TDECQ Calculation According to D3.1

IEEE 802.3dj, IEEE 802 July Plenary Meeting

Comments addressed: 95, 96, 97, 103, 205, 227, 229, 230, 263, 264, 267, 287

Eye Diagram Based on Scatter Plots

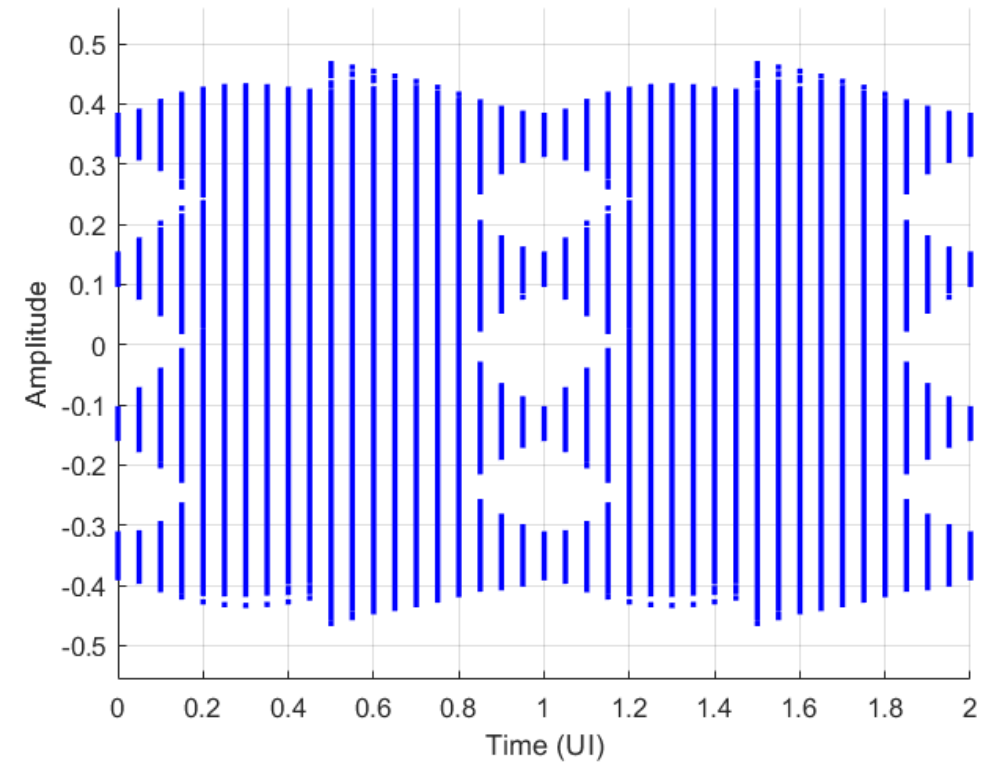
- Based on phase steps of $T/20$
- Density can be increased by choosing denser phase grid
- Histogram locations need not be optimal, but must be located around the discontinuity plus $T/2$.

Comment(s) addressed: 96, 97, 263,

Example: Effective rate $> M/T$

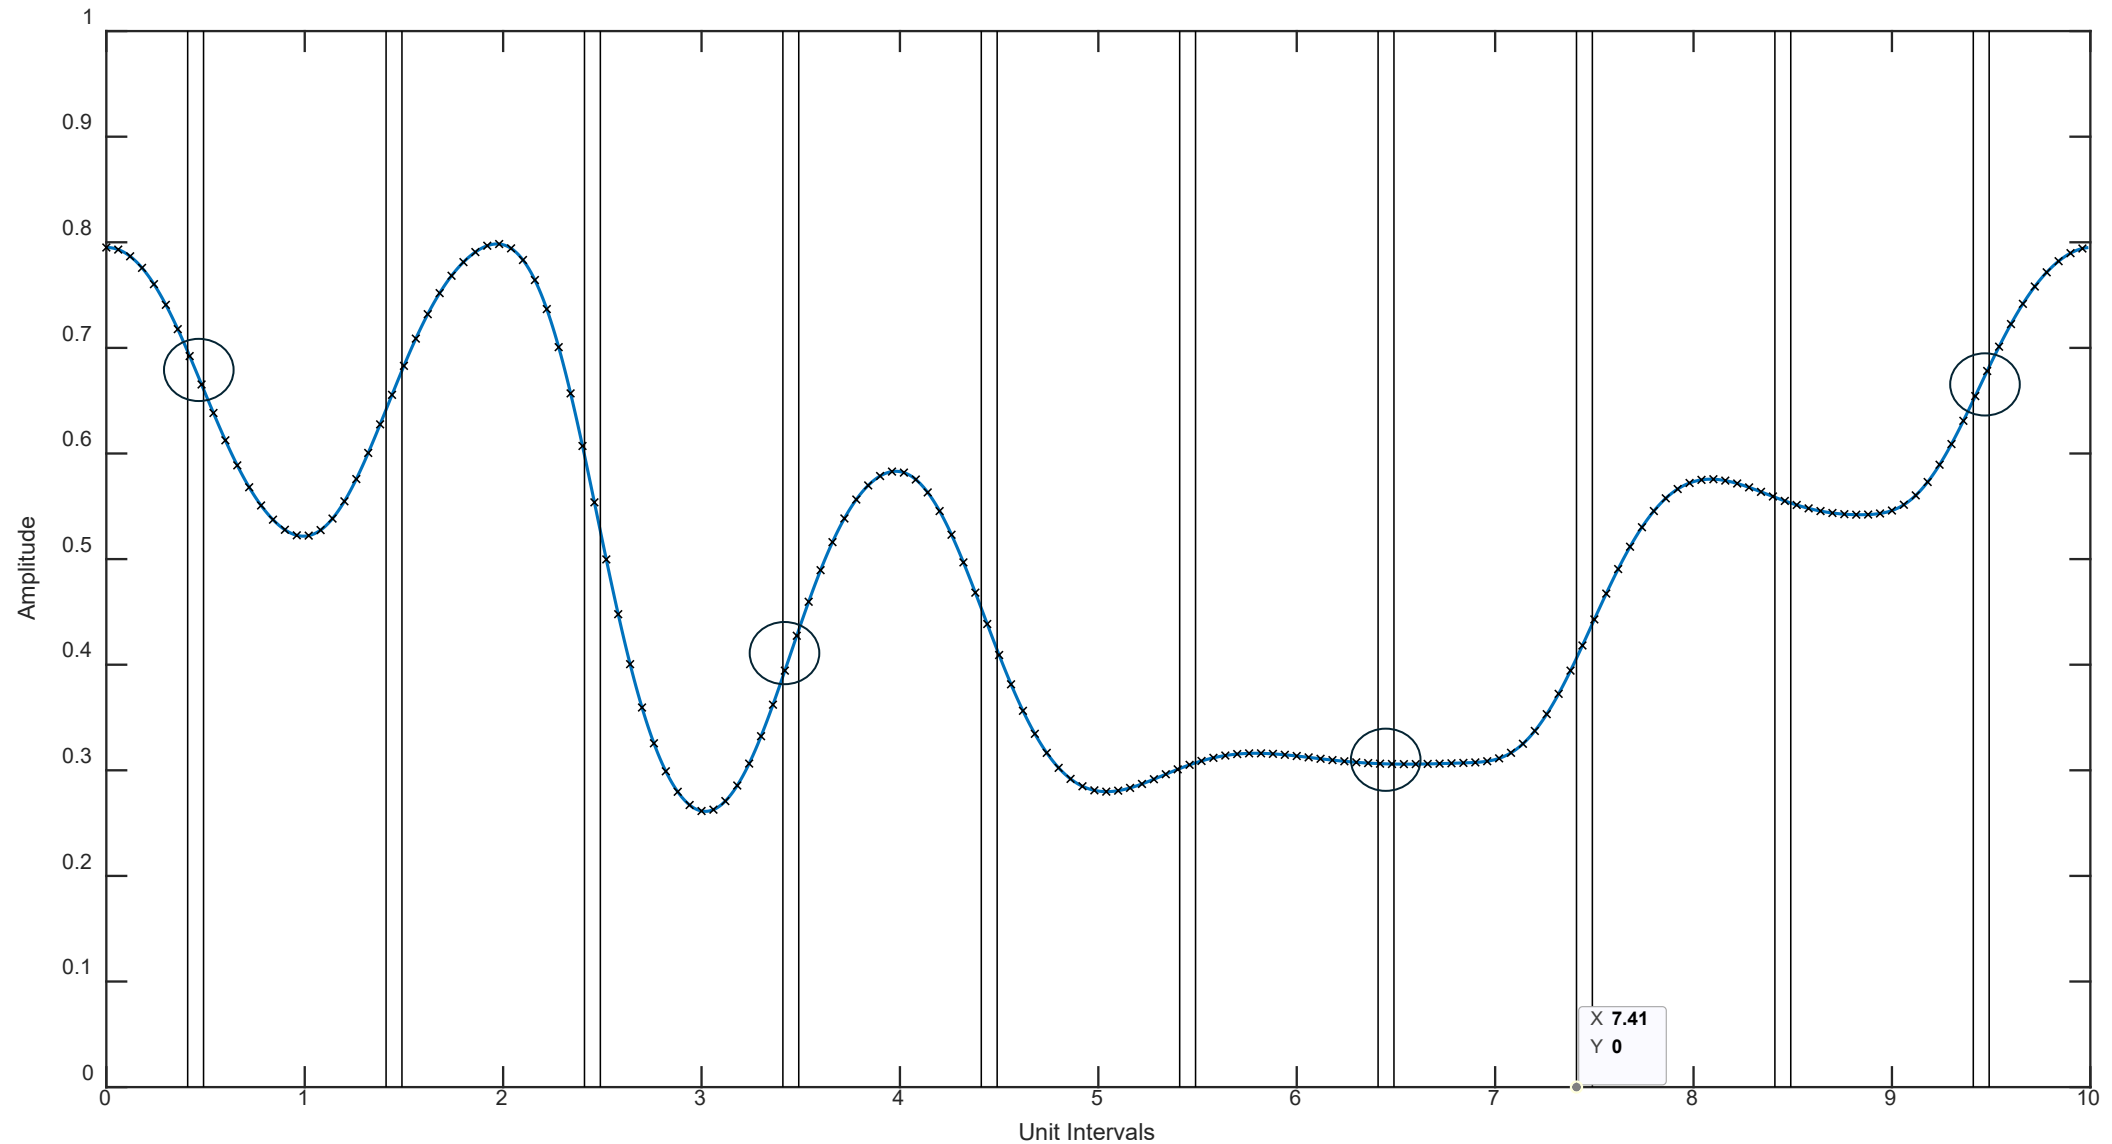
- If we don't interpolate and use finite width histogram bins, we risk missing samples for some symbols or having multiple samples for certain symbols
- Suppose the histogram slice width is T/M . (Currently, $M=25$.) If the effective sample rate is:
 - Greater than M/T , some slices will capture multiple samples for a given symbol
 - Less than M/T , some slices will have no samples for some symbols
 - Equal to M/T , then there is no need to have a finite width; you get one sample of each symbol in the slice at the same phase

- Specify that the histograms are collected at $\phi_0 \pm .05 T/2$, interpolating if necessary
- Properly account for noise
 - Account for the effects of interpolation, if used
 - De-whiten the noise captured by the sampling scope
 - Details can be added, or we could simply load it into a statement as we do presently:
